Environmental Review Team Report

Lantern Hill Campground

North Stonington, Connecticut

March 1984

Preliminary Site Plan

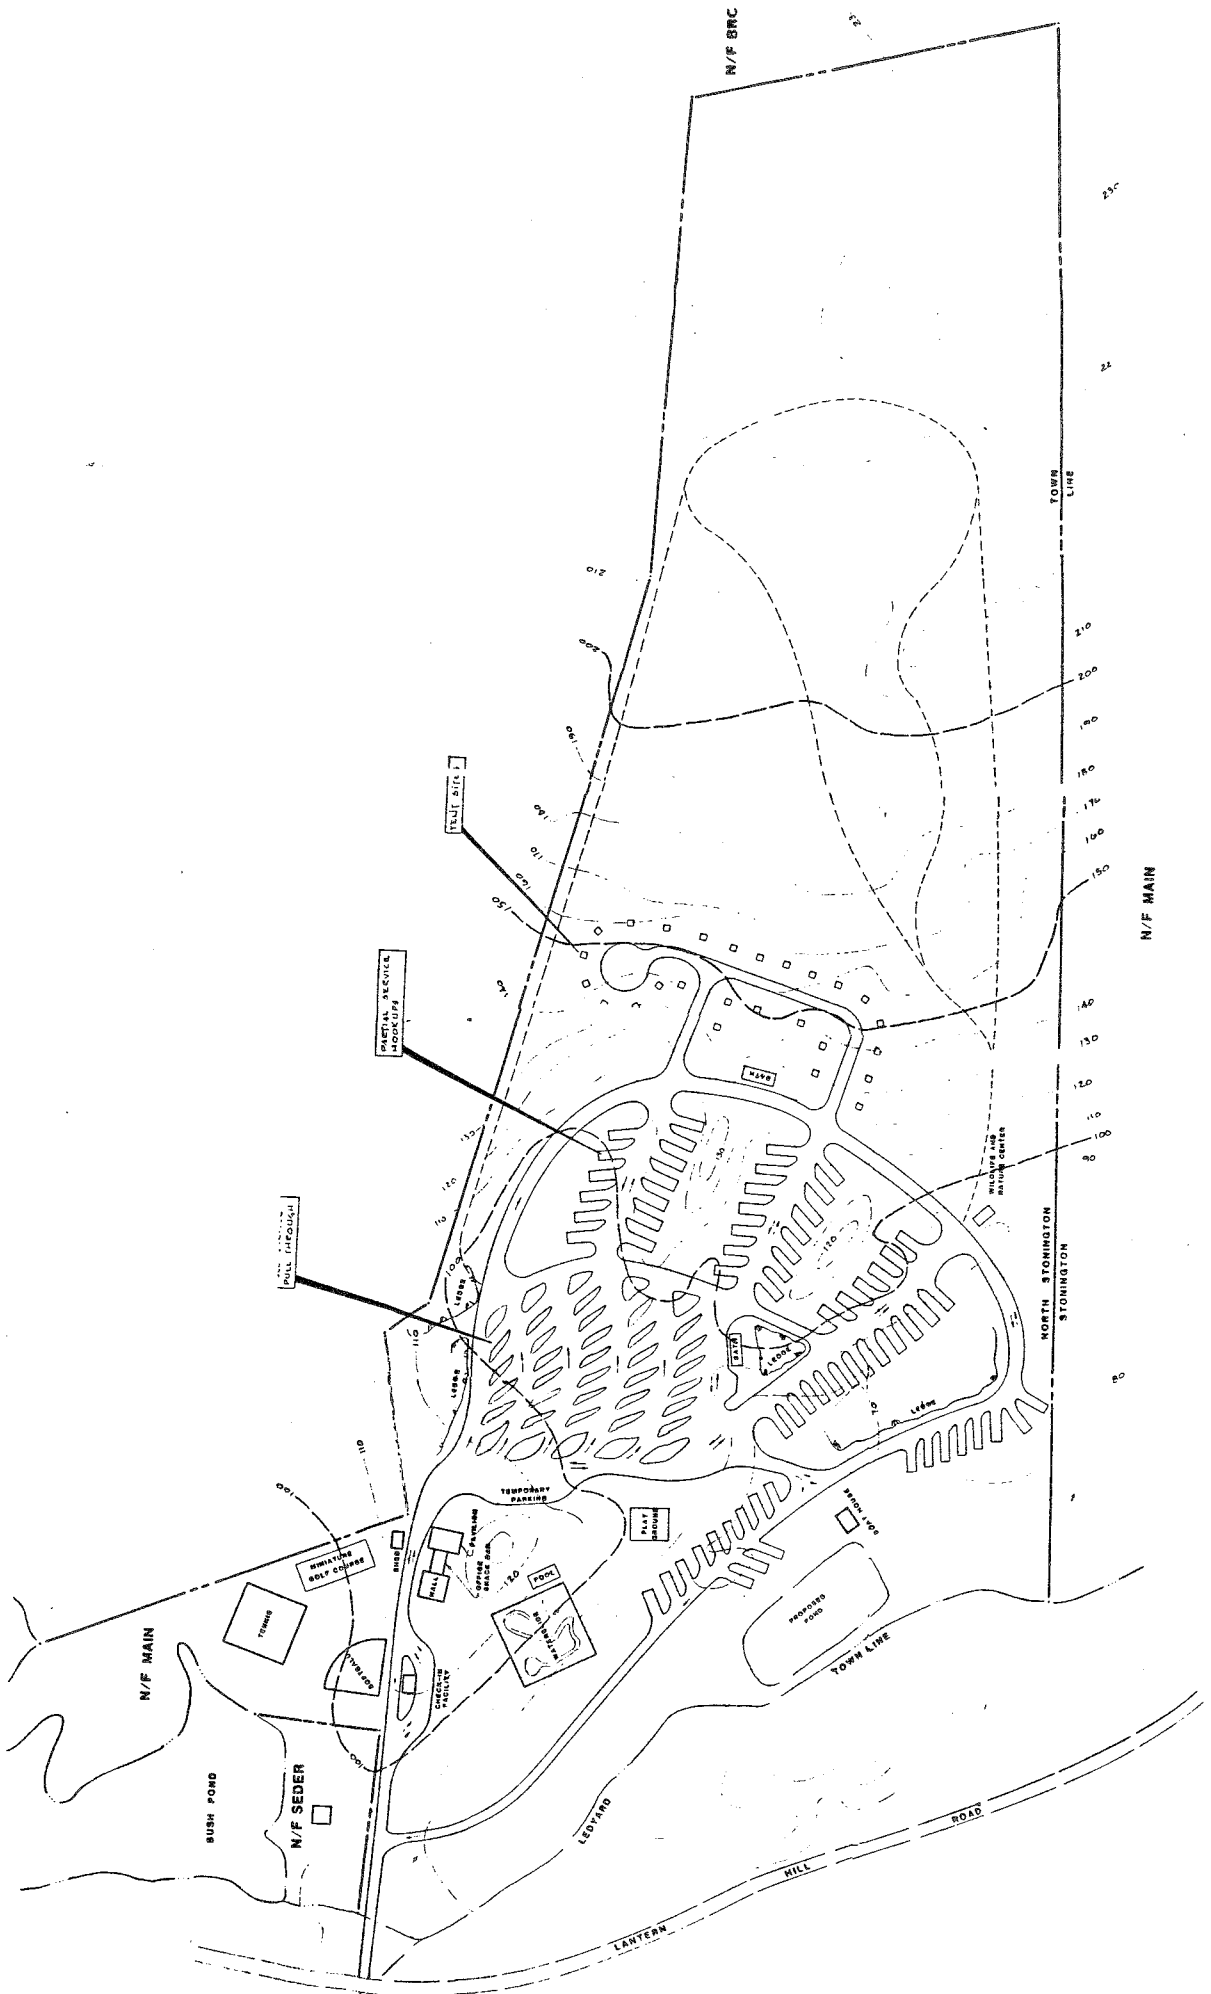
Preliminary plans show 125 campsites proposed for the area. Twenty-six of these are tent sites, 34 are full service sites (electrical facilities, sewage disposal), the remaining 65 are partial service sites (electrical facilities only). Two bath houses are proposed to serve the site. A variety of recreation facilities are also shown on the proposed site plan. These include tennis courts, miniature golf, a softball field, a water slide, a pool, a playground, an office and snack bar building, and a wildlife/nature center. A small pond is also proposed for the campground. Access to the site would be provided from Lantern Hill Road. The property is presently being considered for a zone change to allow for campground development.

Site investigation revealed that the area identified for full and partial service campsites has severe limiting factors for the installation of campsites. A major portion of the campsites are proposed to be located in a natural hollow between two large ridges of ledge to the north and south and a steeply inclining area to the east. This area is very stony and includes several intermittent streams and wet areas.

The ledges which help to create this depression are in themselves an unfavorable feature for a campground. Adventurous children will find the ledges and rock outcroppings "attractive nuisances" where climbing the ledges could be a threat to their safety.

Slope and wetness offer other problems with establishing suitable campsites and roads. Ideally campsites are to be located on level, well drained soils; the area proposed for development does not meet either of these requirements. Seasonal water would cause problems with site and road stability during the spring and fall of the year. The installation of sewer, water and electrical lines would also be complicated by these conditions.

Slope becomes a real problem with road layout. Because the area designated for partial service hook-ups is on a steep incline, vehicles may find it difficult

to maneuver while pulling a travel trailer. The recommended maximum road grades are minus 6 percent and plus 4 percent, most of the proposed campsites are located on grades well in excess of the recommended limits.

Drainage Areas

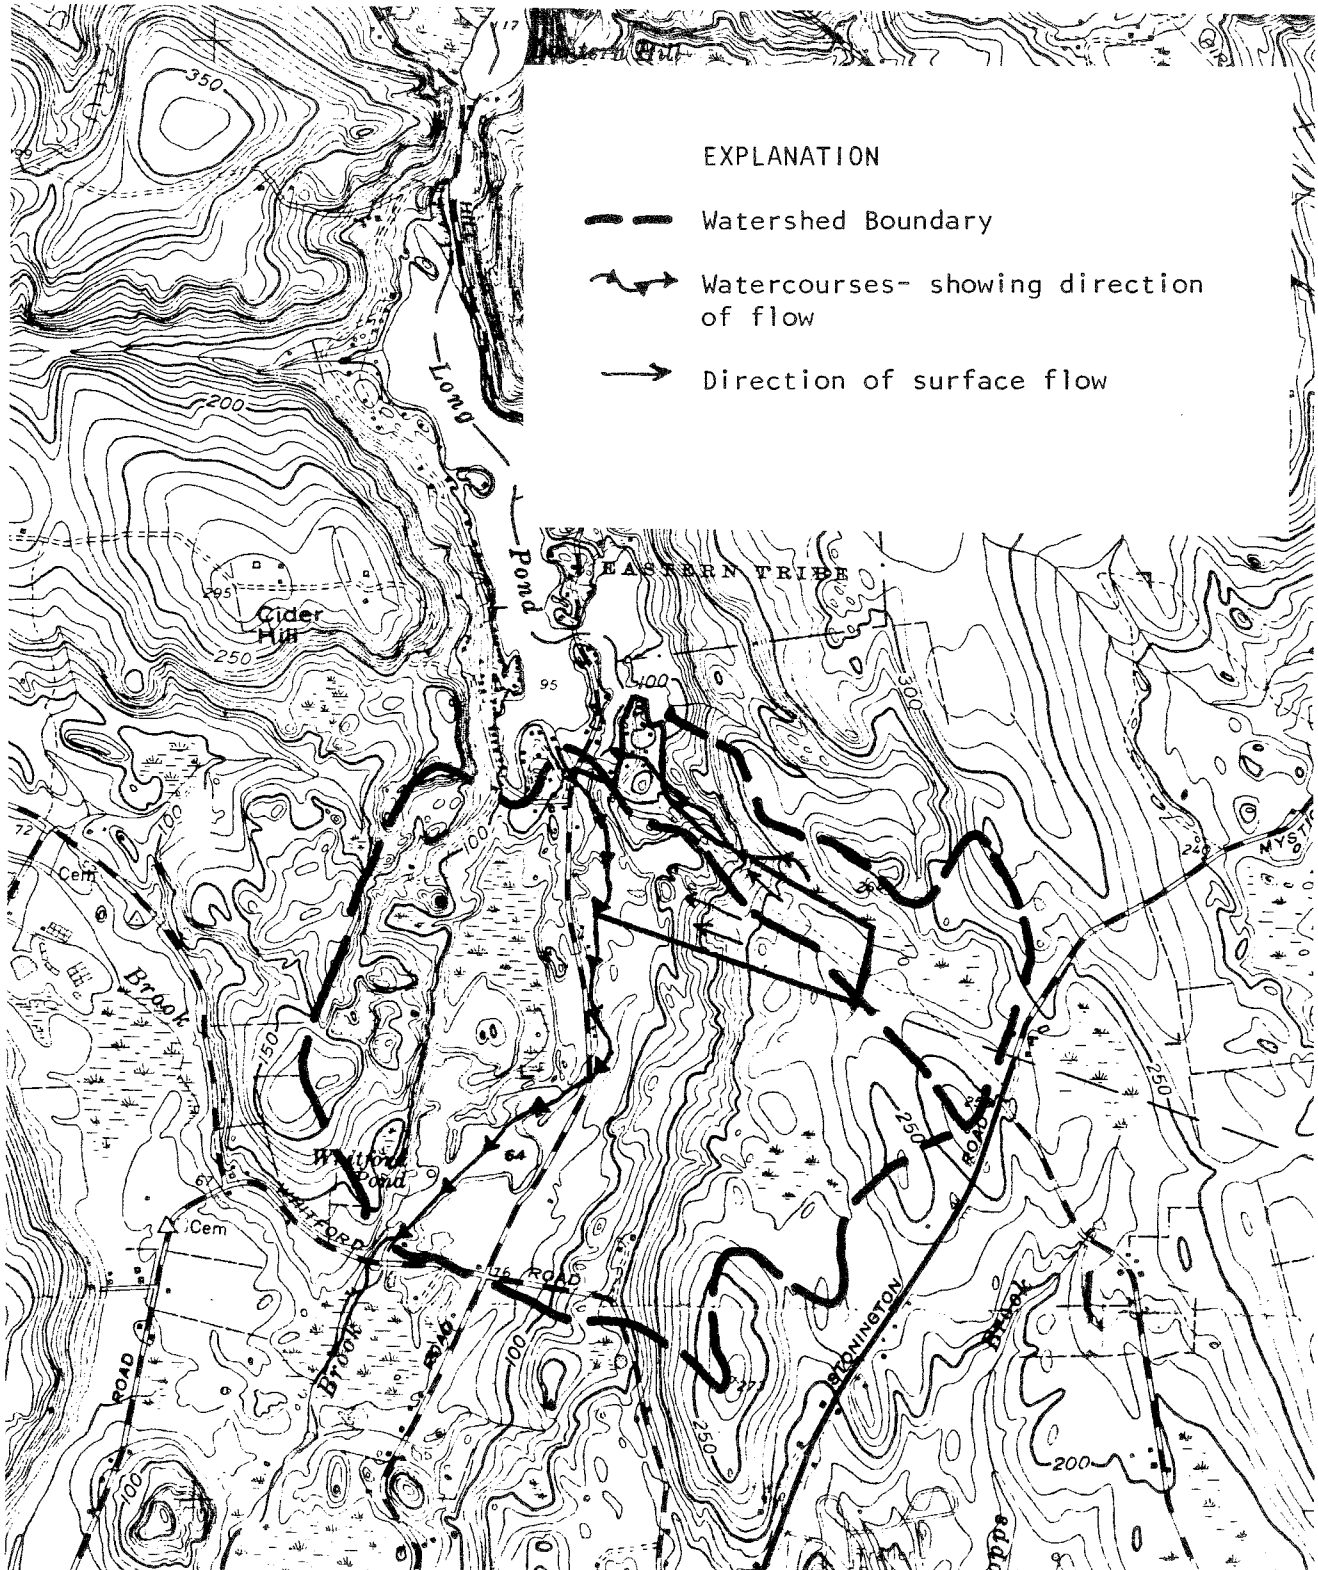
Development of the site as a campground will cause at least a slight increase in runoff, but unless the total amount of impermeable surfaces created were large, the increases should not have a significant affect on peak-flows on nearby streams. These increases would result from soil compaction, removal of vegetation, and placement of impervious surfaces (roof tops, roads, and parking areas). According to the project engineer, access roads will be gravel packed as opposed to paved roads.

It is recommended the project engineer prepares a stormwater management plan which also incorporates erosion and sediment control measures for the Town to review. When formulating the stormwater management plan, the project engineer should direct his attention to the culvert passing under the access road leading to cottages and mobile homes at the northern tip of the property. On the day of the site review,

it appeared that the corrugated metal pipe may not be functioning properly. There is visible evidence that the brook flooded the road in this area, resulting in erosion problems. If peak flow increases to this stream occurred as a result of development on the site, the existing problem may be further aggravated, possibly making the road impassible during periods of heavy rain. This should be of concern since the road is the only access to the five or six cottages and mobile homes on the northern tip of the site.

Vegetation

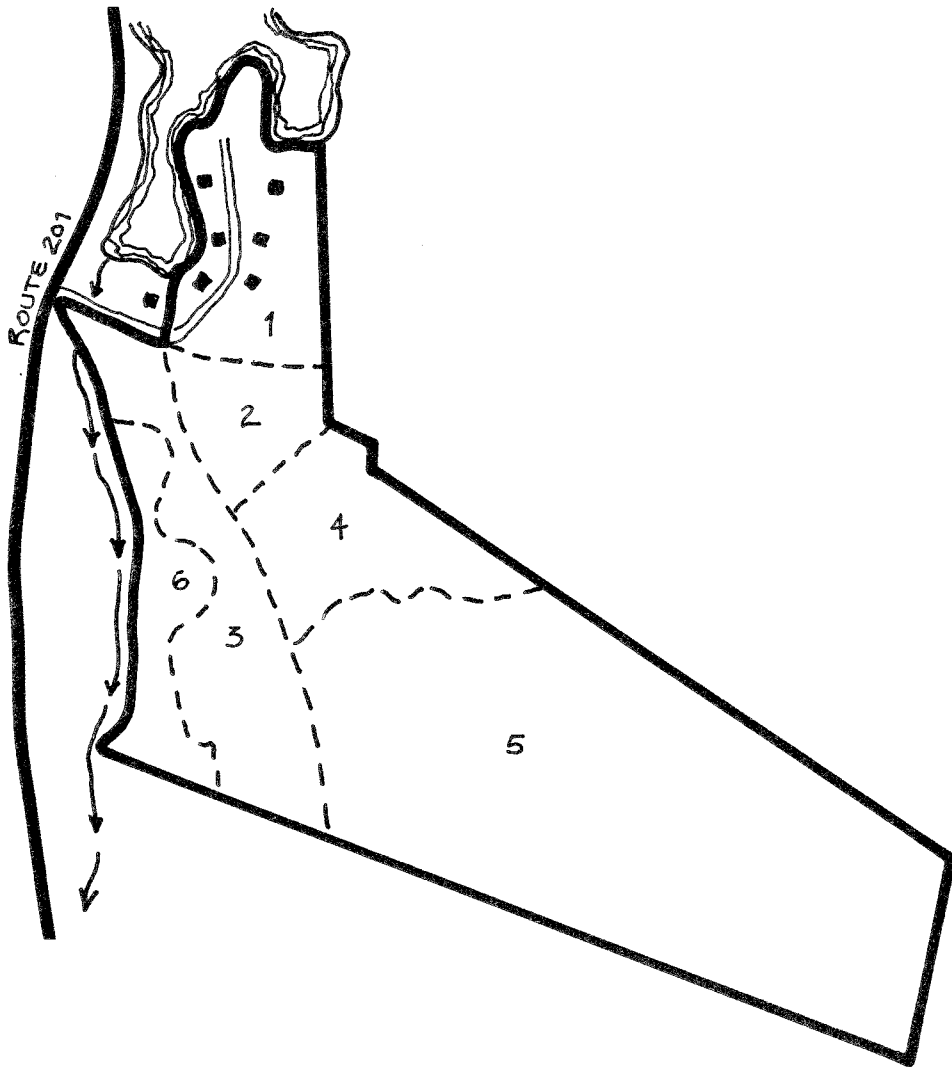
Development of this area according to the plans presented, will have considerable effect on the current tree growth. First, in the area planned for recreation development, the field area, can be filled in and leveled to make the area suitable. The pool, waterslide, hall and snack bar on the steep knoll of shallow soils will necessitate cutting and filling of the site; in addition, there will be a large number of foot trails, all of which will be detrimental to the tree growth. All walk areas should be paved or preferably heavily mulched with chips to prevent compaction and erosion of the soil. Some facility locations will have to be changed as the filling necessary to make level areas will involve areas much larger than the facility warrants.

With good road planning and drainage, the tent site area should have little effect on the present tree stand. Although the site, in general, appears to have a good potential for a campground. The project should be redesigned to take advantage of the natural resources present. This would eliminate the drastic changes that the current plan would produce.
